Manual Change Information

# TM-1010PN-K

Since some details of the TM-1010PN-K service manual (No.51181, Jan. 1997) were changed, we are informing you of these changes and of the new descriptions.

SIGNAL PW BOARD CIRCUIT DIAGRAM(Page 2-8)

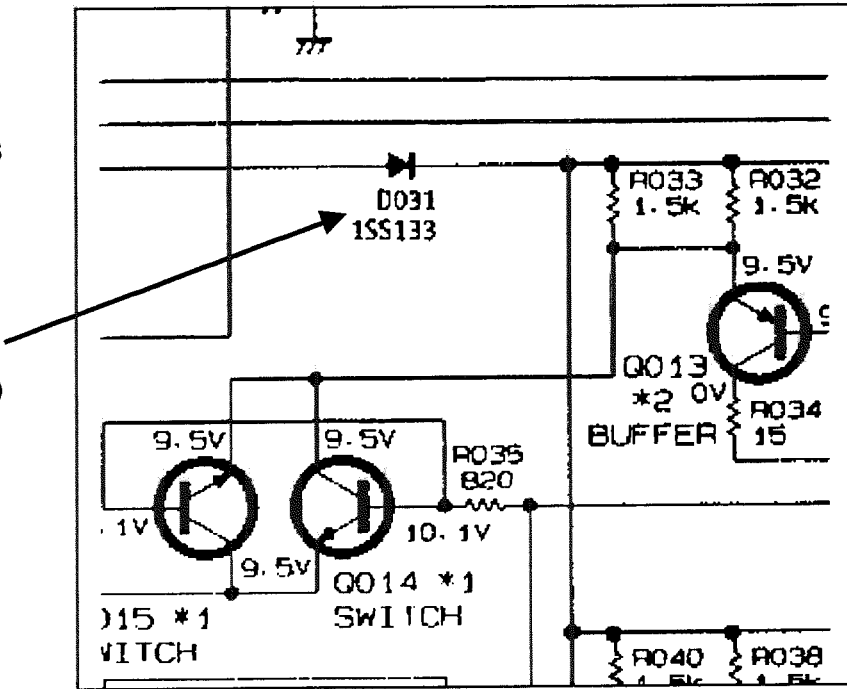
PREVIOUS  
(FX-1089A)  
1SS133-T2

NEW  
(FX-1089B)  
1SS353-X

SIGNAL PW BOARD CIRCUIT DIAGRAM(PAGE 2-7~2-8)

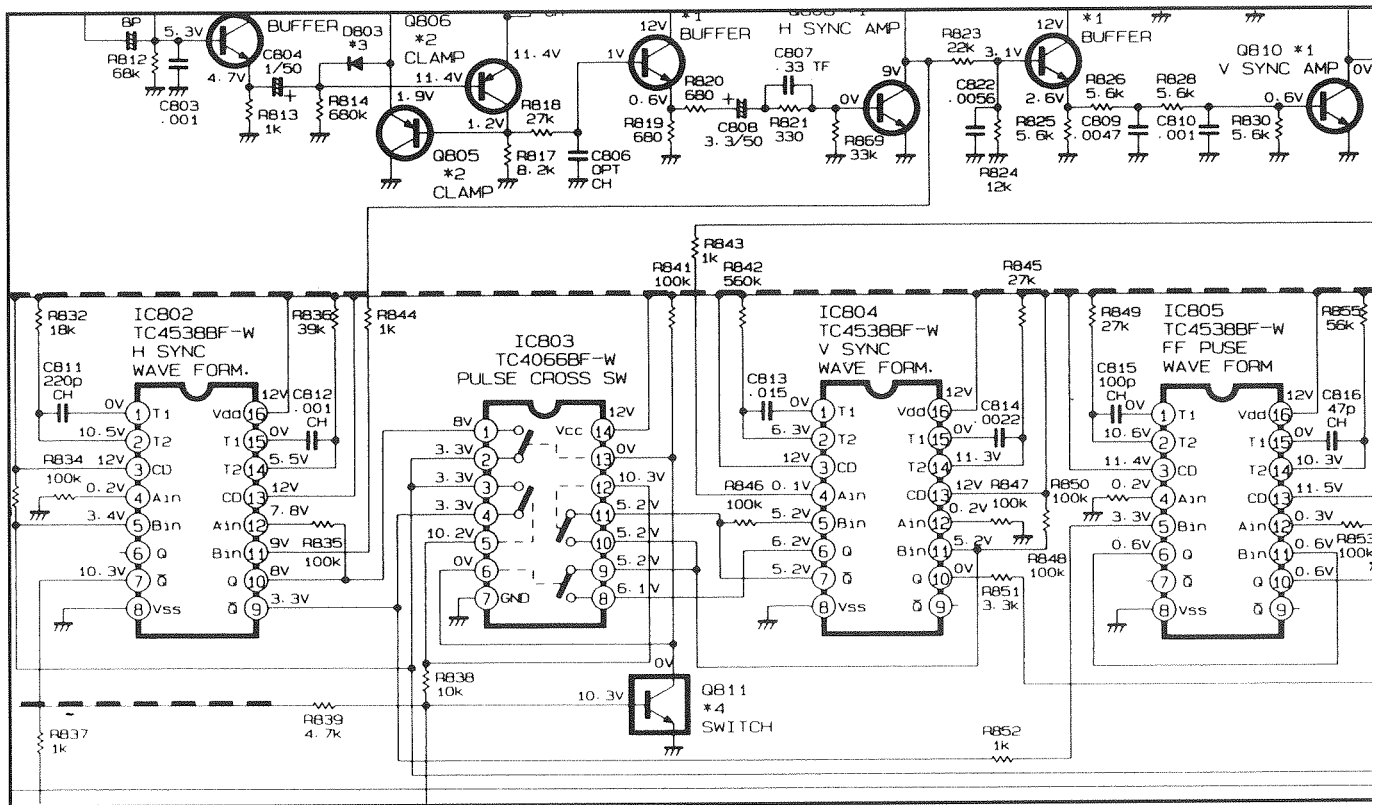
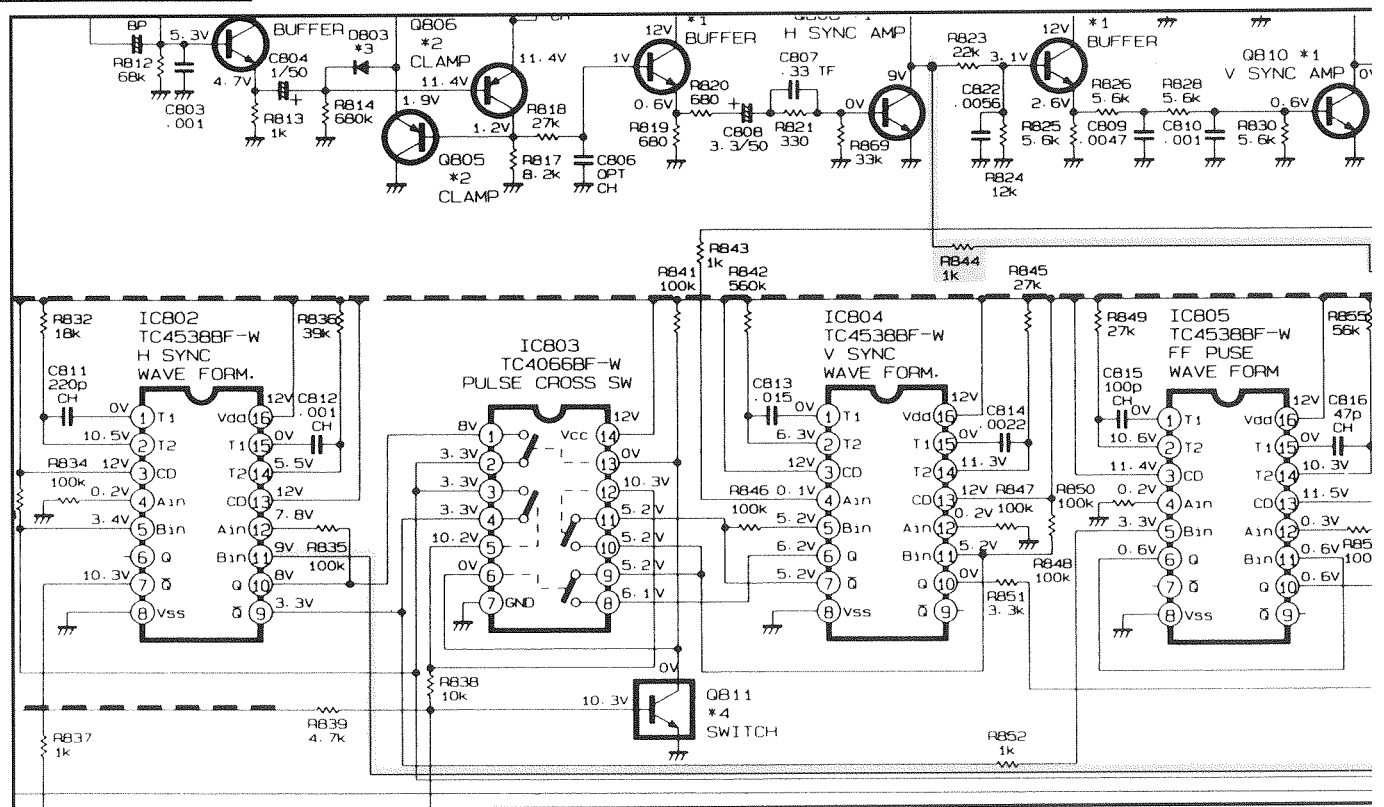
The circuit has been changed as follows in order to accommodate the DVD copy guard.

PREVIOUS (FX-1089A)

NEW (FX-1089B)
